Interactive comment on “Deep soil water ^{18}O and ^2H measurements preserve long term evaporation rates on China’s Loess Plateau” by Wei Xiang et al.

Response to Anonymous Referee #2

Fig. 1. Comparison of evaporation estimates derived from the regional LMWL and the site-specific LMWL.

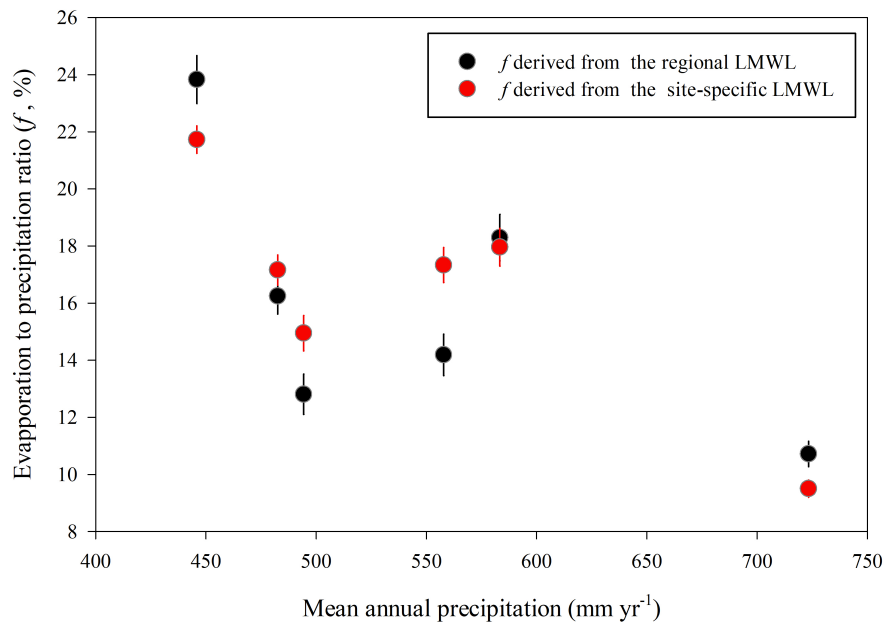
1. The main issue of the presented study is the lack of information of the isotope ratios in the infiltrating rainfall at the individual sites. While it is unclear how the IAEA rainfall data were used in the study, the uncertainty introduced by not having site-specific rainfall isotope data are not assessed and thus not accounted for. If the actual rainfall isotope ratio differs from the IAEA data derived local meteoric water line, the

lc-excess for the soil water ends up being offset over the entire depth profile. In such case, one would assume negative lc-excess results from transport of partly evaporated shallow soil water into deeper depths. For example, if the intercept of the LMWL is overestimated, the lc-excess values of the soil water will be underestimated. If the slope of the LMWL will be underestimated, then lc-excess values of deeper soil water might be underestimated. I now see that this aspect has been already addressed in the response to Reviewer 1. If I use some numbers provided in Fig. 2, assuming there is $d2\text{H} = -68$ permill and $d18\text{O} = -9.2$ permill in the subsurface (from reading the graph), the lc-excess could range between -4 and 9 permill depending on the assumption of slope being 6.11 or 7.56. Such uncertainty is not discussed yet in the manuscript.

Response: To address your concerns, we will add site-specific rainfall isotope data for six of our soil sites that are available. Indeed, the lc-excess method presented in this study requires the site-specific LMWL parameters (i.e. slope and intercept) for each soil sampling site, and it should be more accurately if the site-specific LMWL is used. However, for the method to be widely applicable, a method should not require data that are not widely available. Because LMWL may not be available at each site of interests, we constructed the regional LMWL based on IAEA data from five stations, and use it for all of our sites for evaporation calculation. If the site-specific LMWL is much different from the regional LMWL, this, as you stated, would introduce uncertainty.

To assess this uncertainty, we obtained the site-specific LMWL for six of our soil sites, and compared the evaporation estimates obtained from regional LMWL and site-specific LMWL. Figure 1 showed that the difference between the two methods are very small, with the difference ranging from -3.2% to -2.1%. This suggests that the regional LMWL may be acceptable if site-specific LMWL for a individual soil site is not available. We will add this important part in the method, result, and discussion sections of the revised version.
